UNITED STATES PATENT AND TRADEMARK OFFICE

APPLICATION NO.	FILING DATE	FIRST NAMED INVENTOR	ATTORNEY DOCKET NO.	CONFIRMATION NO.
10/533,766	05/04/2005	Takemi Matsuno	26281-09A	7948

Office Action Summary	Application No.		Applicant(s)	
	10/533,766		MATSUNO, TAKEMI	
	Examiner		Art Unit	
	Constance B. Salters		3609

DETAILED ACTION

FIG. 8

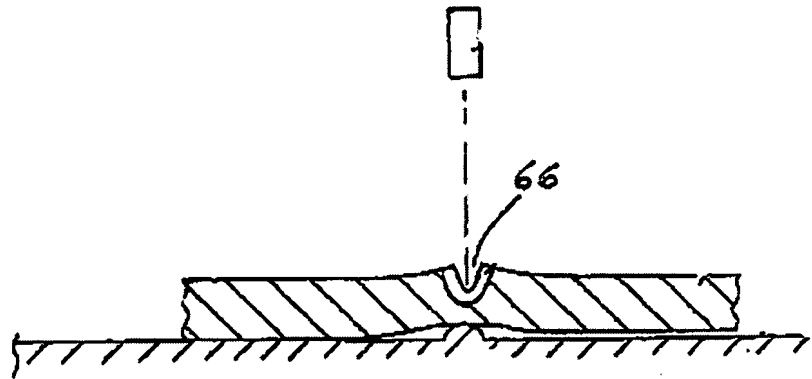
In Re claims 1 and 2, Evans et al, US '512, discloses a V-shaped groove or "score line 66" in an automotive trim cover of an airbag, which "has a depth of about 10% to about 90% of the thickness of skin" (Column 3, lines 62-63), as shown in Figure 8 below, which is "adapted to assume a substantially V-shaped groove" and is apparent "when the skin is bent with its back surface convexed".

The examiner interprets a score line to be a "break-scheduled line". It is evident the score line will be substantially invisible or flat when the skin is flattened.

FIG - 8

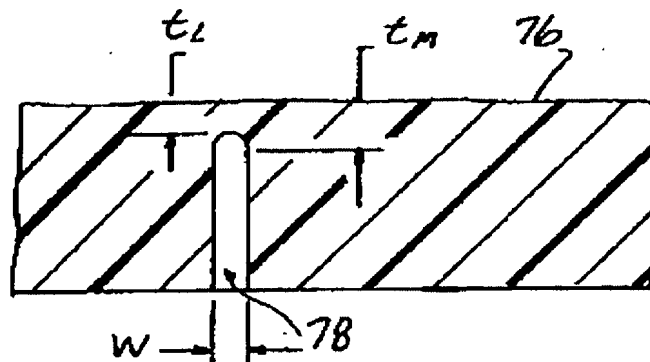
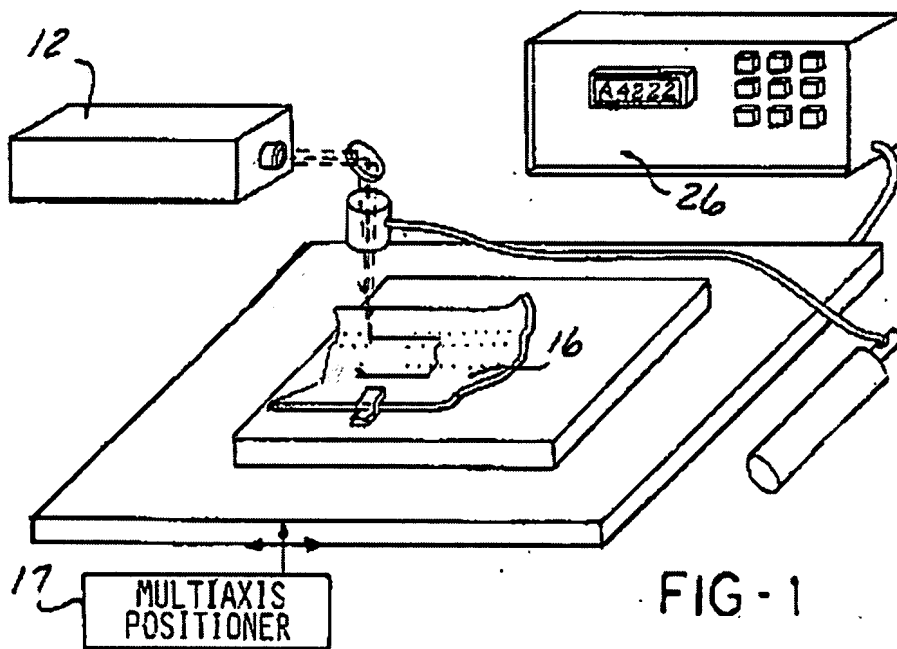
In Re claim 1, Bauer, U.S. '776, discloses a vehicle upholstery member or automotive interior trim piece skin with a groove scored to "a depth on the order of 20-80% of the thickness of [the] cover layer" (Claim 1, Column 9, lines 39-40), as shown in Figure 8 next page. The examiner interprets a score line to be a "break-scheduled line". It is evident the score line would assume a substantially V-shaped groove when the cover is convexly bent.

FIG-4

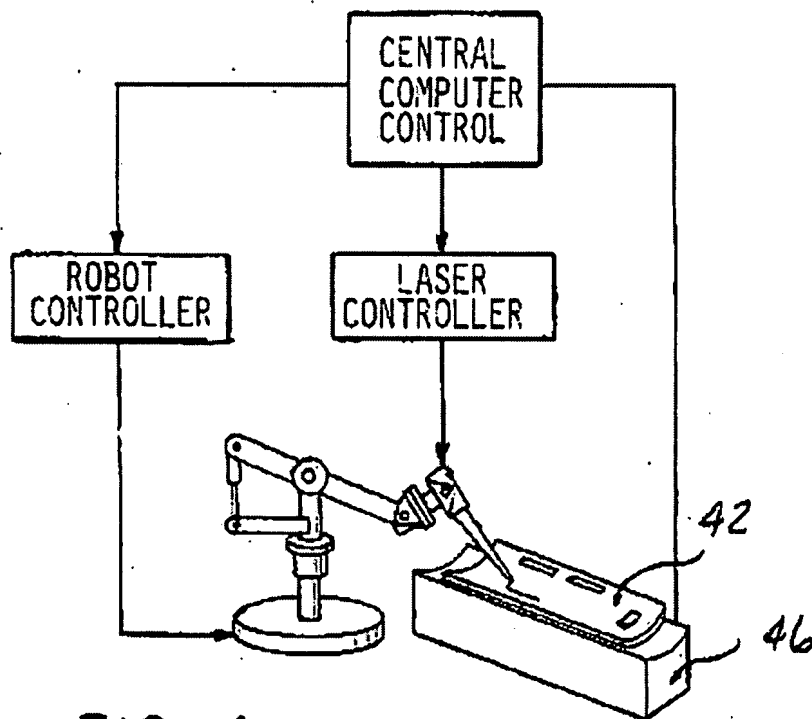
(Column 6, lines 18-21) and the skin or "cover **42** is fixtured on an ultrasonic sensor **46**

which generates signals corresponding to the thickness of material remaining after the groove scoring is produced" (Column 6, lines 62-64). See Figure 4 above.

In Re claims 10-12, Bauer, US '776, teaches the laser motion and depth, while scoring the skin, are detected and the thickness of the remaining portion of the skin is controlled and measured by the computer based controller which controls the multiaxis positioning system and the device for these methods are inherent in the process. See Figure 4 above.
